Greenway Property, Preliminary Plan of Subdivision, 1-20120050

Staff Report Date: 11/18/11

RE: Preliminary Plan #120120050
Greenway Property, Bethesda

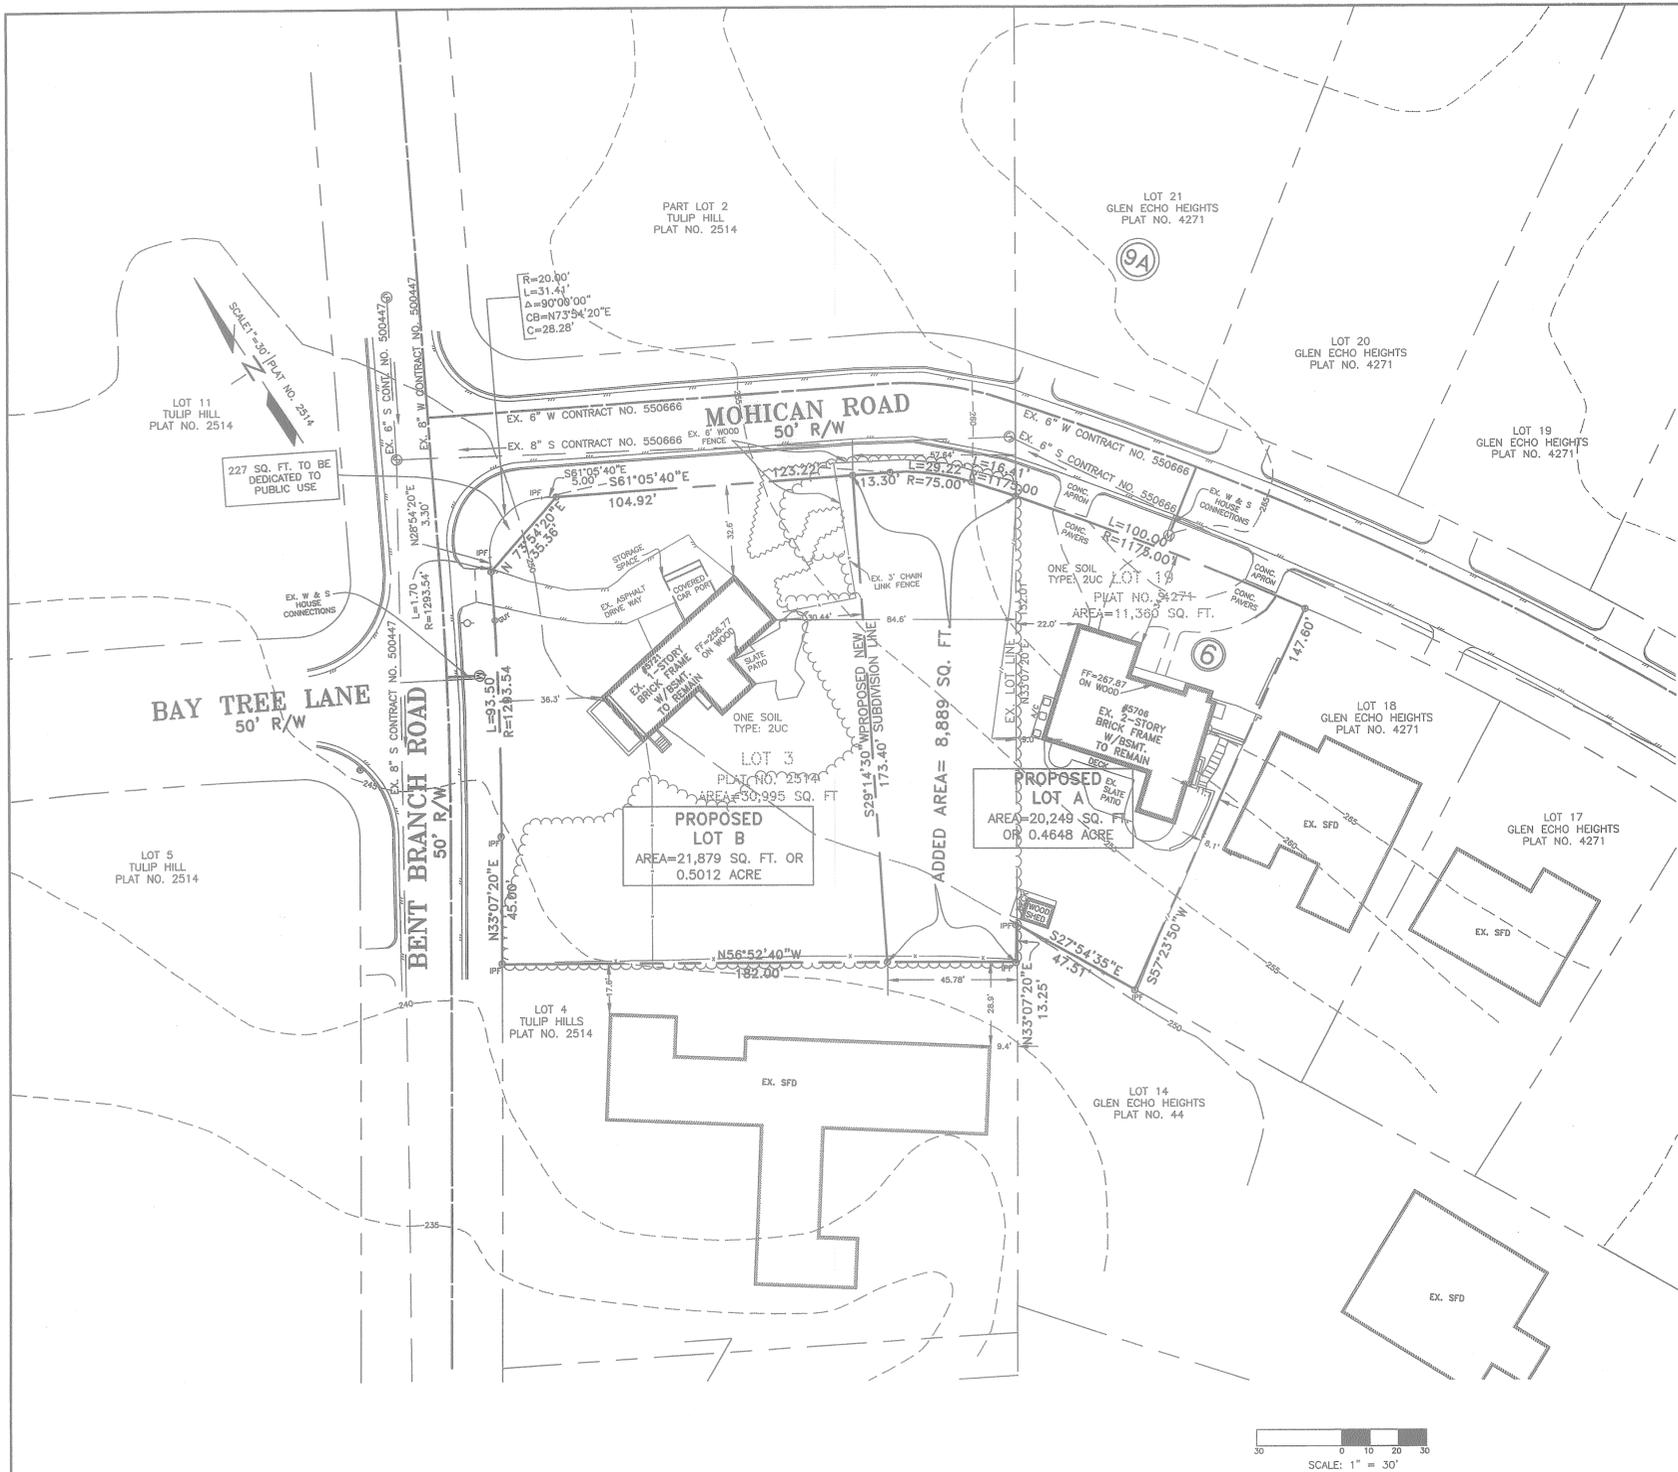
We have completed our review of the revised preliminary plan dated October 26, 2011. An earlier version of this plan was reviewed by the Development Review Committee at its meeting on October 17, 2011. We recommend approval of the plan subject to the following comments:

1. Dedicate right-of-way truncation at the intersection of Bent Branch Road and Mohican Road.
2. Execute and record a Declaration of Covenants (for Road Improvements) for Bent Branch and Mohican Roads, prior to Department of Permitting Services' approval of record plat. Add deed reference for same on the record plat.

DATE	REVISIONS
10-20-2011	R/W TRUNCATION PROVIDED AT INTERSECTION TO BE DEDICATED FOR PUBLIC USE. ADDED EXIST. WATER & SEWER CONNECTIONS FOR BOTH LOTS, ADDED EXIST. WOOD FENCE ALONG MOHICAN ROAD.
